Historic Landmarks and Preservation Districts Commission

Report to the Committee

Case No: 17COA1283
Classification: Committee Review

Property Address: 2440 Grinstead Drive and 1101 Ray Avenue

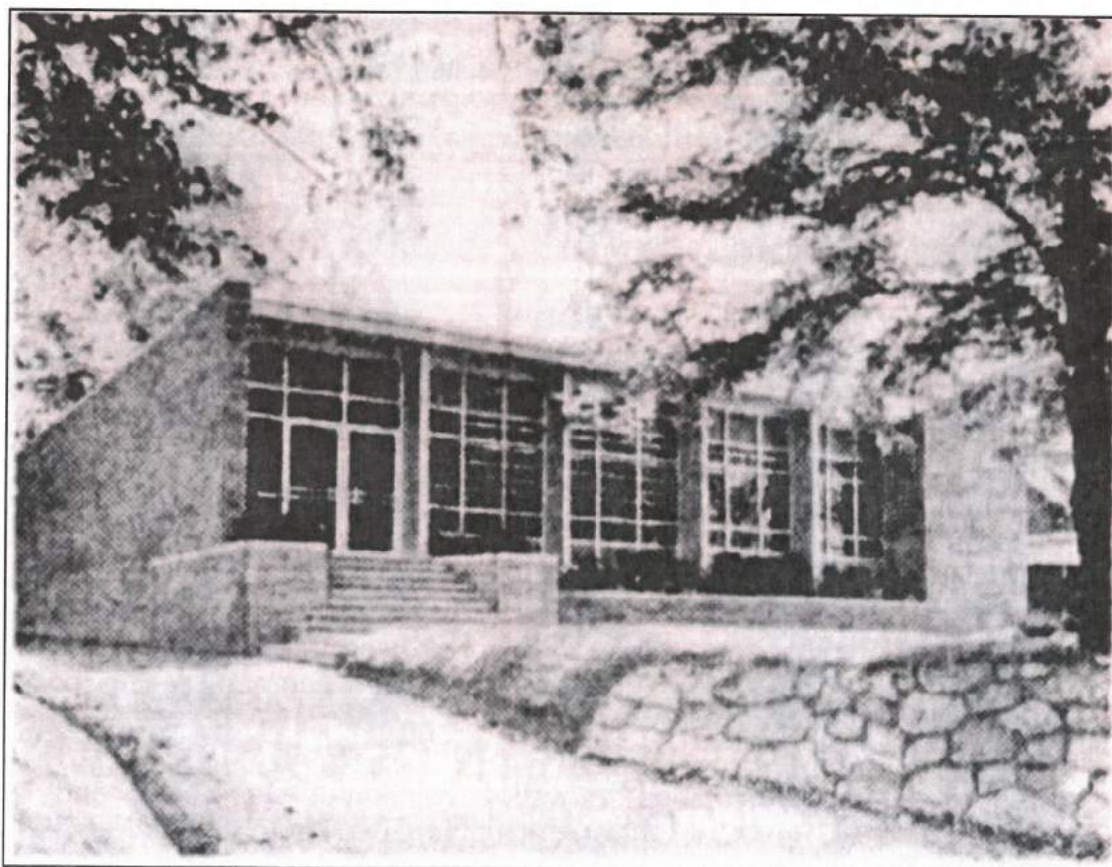
2440 Grinstead Drive is located on the south side of Grinstead Drive, one lot east Ray Avenue. It is zoned C1 within the Traditional Neighborhood Form District. The site contains the one-story masonry building, formerly known as the Bernard R. Meidinger & Associates Building, Tropus Building, and Collegiate Fine Arts Building. The building was constructed in 1960 for Bernard R. Meidinger & Associates and it was designed by local architecture firm Arrasmith and Tyler who also designed the 800 Building on Fourth Street and the Natural Sciences Building on the University of Louisville Campus. The six westernmost bays of 2440 Grinstead Drive (from Burger's east to the entry doors) were the original portion of the building. The eastern half of the building was constructed circa 1974 and designed by local architecture firm Tafel and Schickli. 2440 Grinstead Drive is a classic Mid Century Modern design with a mix of vertical and horizontal planes, flat roof line, floor-to-ceiling windows with vertical mullions, spandrel panels, roman brick, and planter boxes.
